CUSTOMER IMPACT ASSESSMENT

**Proposed 30MW
Northland Power
Martin's Meadows, Abitibi, Empire
Solar Generation Project**

Addendum #2

Customer Impact Assessment - Northland Power

Figure 1- Original Proposal for 30MW Northland Power Solar Farm Connection to Hydro One A5H circuit

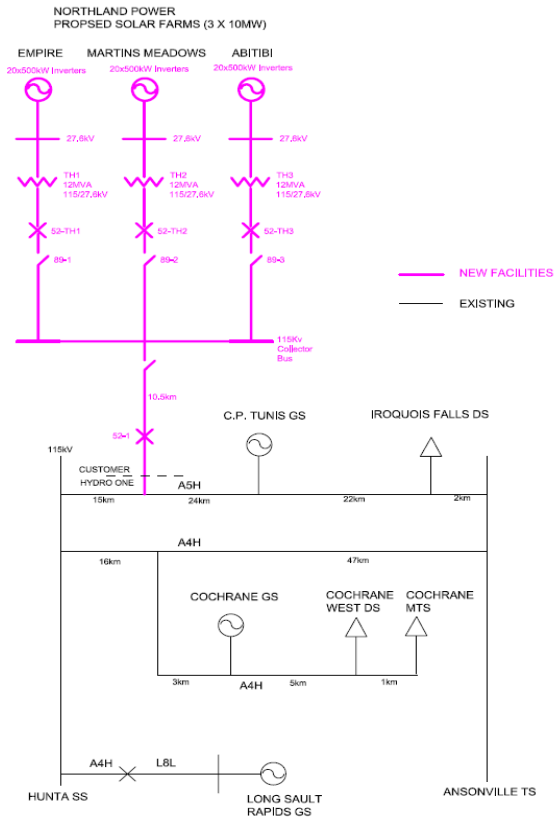
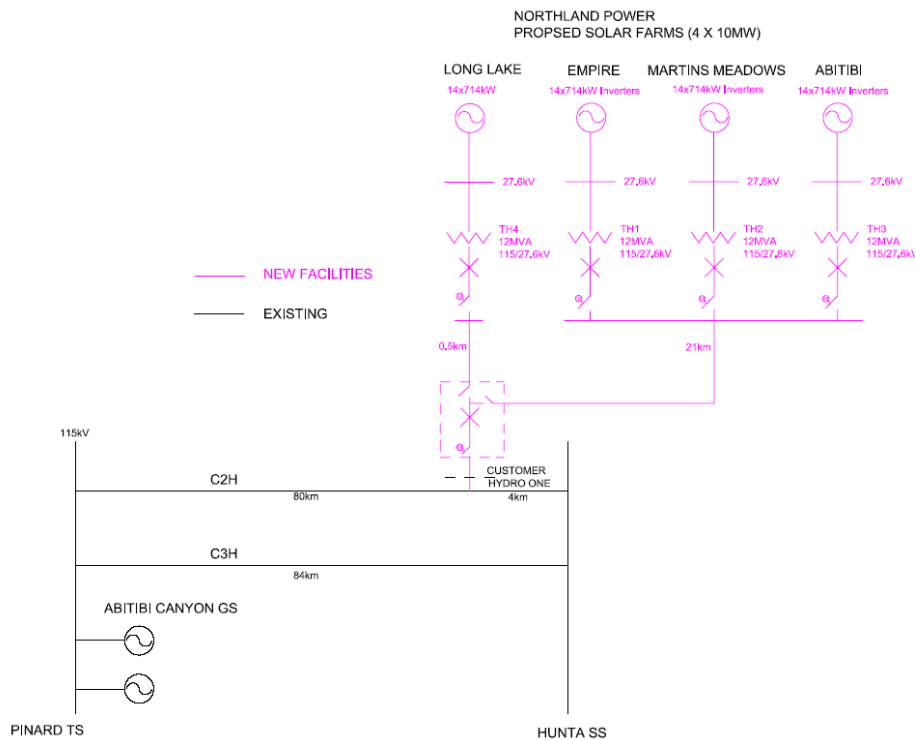
Northland Power will not proceed with the connection of the 30MW solar generating facility (Abitibi / Martins Meadows / Empire) to the Hydro One A5H circuit. This generating project will be connected to the Hydro One C2H circuit. Study results for this connection can be found in *CIA - Addendum #2 – Long Lake #FE8GSGA*

The Northland Power solar generating facility (Long Lake, Martins Meadows, Abitibi, and Empire solar farms) can be incorporated into the 115kV C2H transmission line.

Hydro One customers connected to neighboring circuits will not be impacted by this proposed connection. Short circuit levels and voltage variations are within acceptable limits.

Figure 2- Proposed Northland Power Solar Farm Connection to Hydro One C2H circuit (40MW Total)

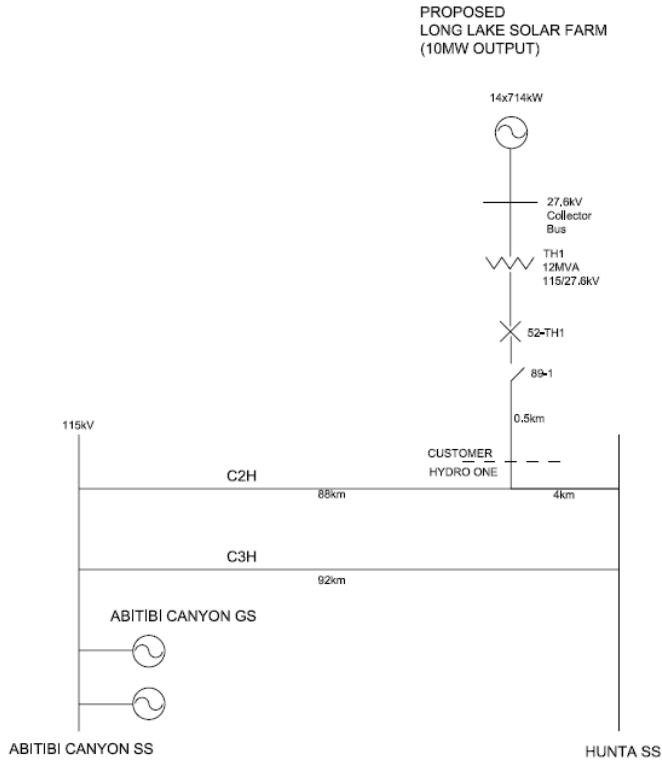
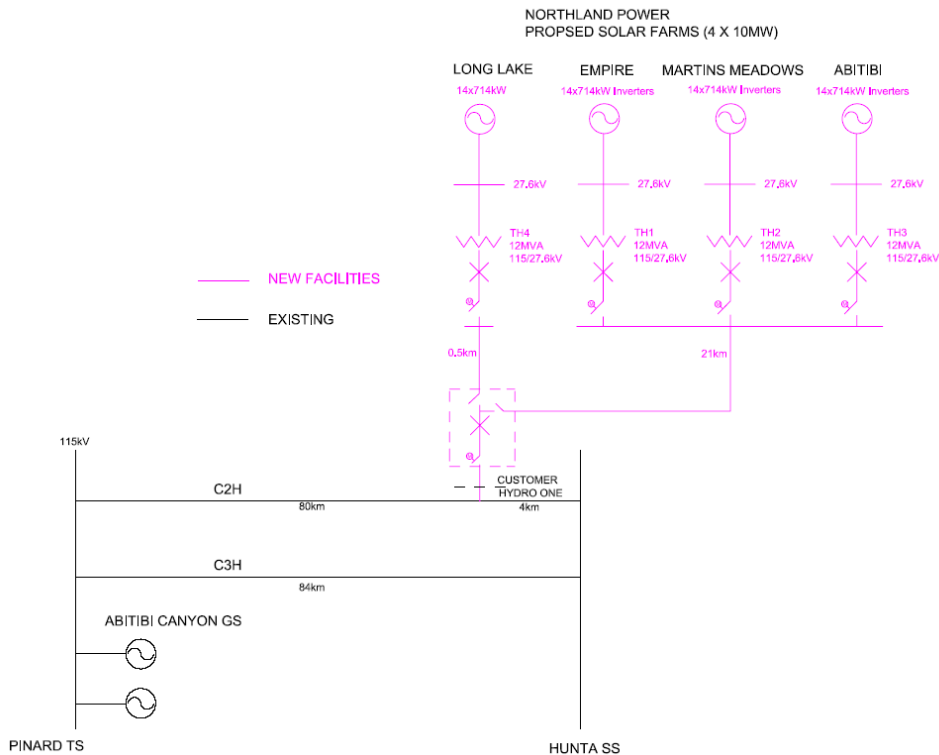
Northland Power confirmed on November 21, 2011 that in addition to the existing 10MW *Long Lake LP Solar Farm* application, 3x10MW solar farms will also be constructed, increasing the total generating capacity of the Northland Power facility from 10MW to 40MW.

As seen in figure 1, the Long Lake Solar farm will connect to the Hydro One system through a customer owned switching station. Three other solar farms (Abitibi, Martins Meadows, Empire) will also connect to the switching station via a 21km transmission line. The customer switching station will consist of a motorized disconnect switch and a circuit breaker which will be used to isolate the entire Northland Power facility during faults or maintenance activities.

Hydro One is presently working to re-terminate the 115kV C2H / C3H circuits from Abitibi Canyon SS to Pinard TS. This reconfiguration is expected to be completed prior to Northland Power energizing their 40MW generating facility, thus, all studies below have taken this reconfiguration into consideration.

The Northland Power solar generating facility (Long Lake, Martins Meadows, Abitibi, and Empire solar farms) can be incorporated into the 115kV C2H transmission line.

Hydro One customers connected to this line will not be impacted by this proposed connection. Short circuit levels and voltage variations are within acceptable limits.
